ERRATA SHEET  
 WRIR 86-4358 PLATE 4

HYDROGEOLOGY OF STRATIFIED-DRIFT AQUIFERS AND WATER QUALITY IN THE NASHUA REGIONAL PLANNING COMMISSION AREA  
 SOUTH-CENTRAL NEW HAMPSHIRE

ERRATA SHEET  
 WRIR 86-4358 PLATE 2

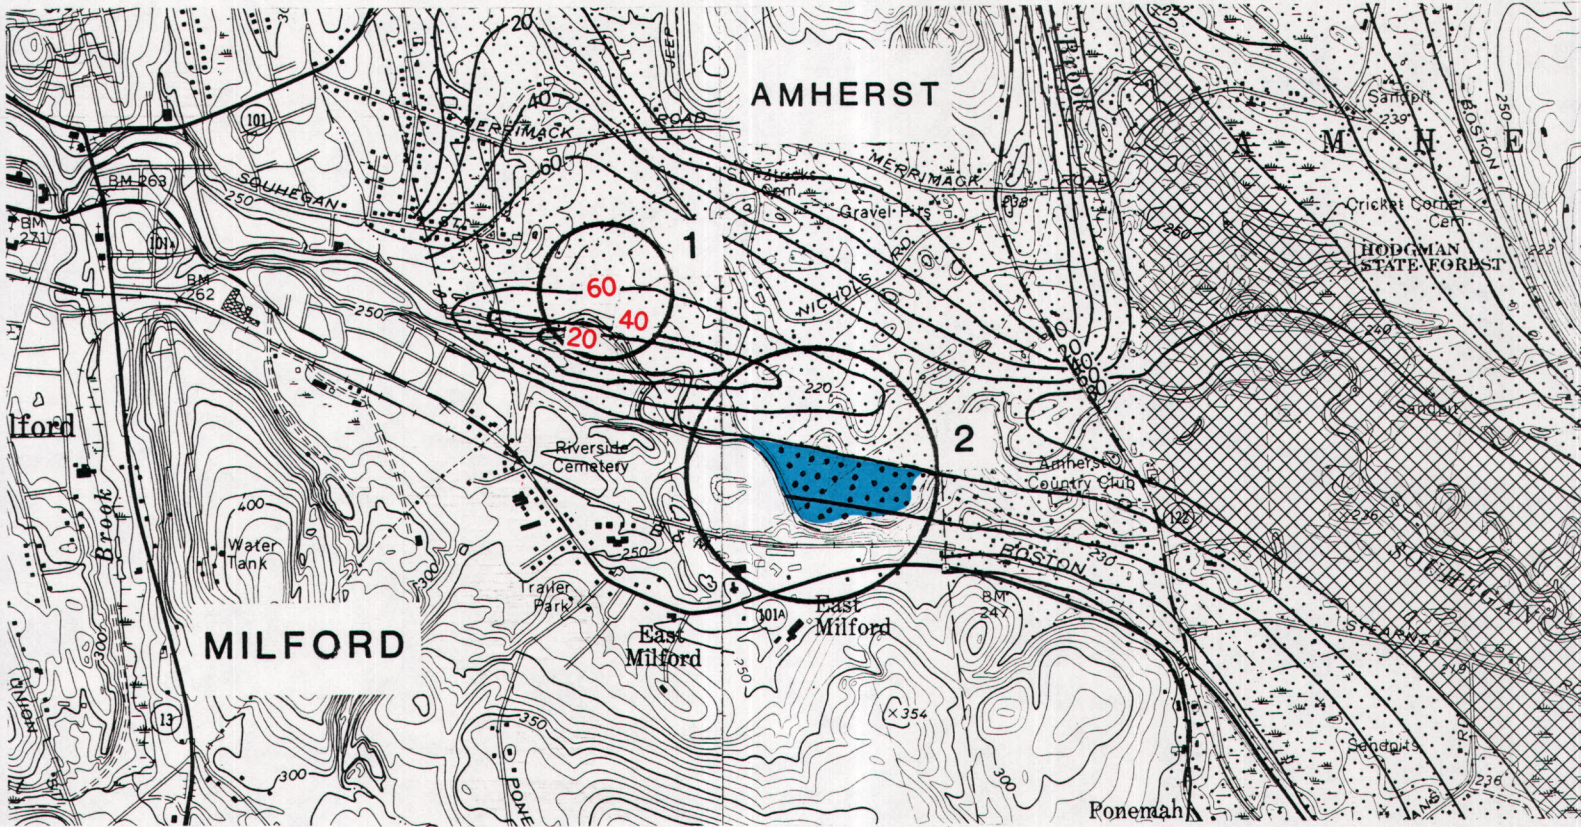
ERROR	TOWN	NEAREST LANDMARK	CORRECTION
1	Amherst	Souhegan River/East Milford boundary	Saturated thickness contour 10 should be 60 and contours 20,40 have been added.
2	Amherst	Souhegan River/East Milford boundary	Saturated thickness, transmissivity, and materials missing from base. Data included on copy below.
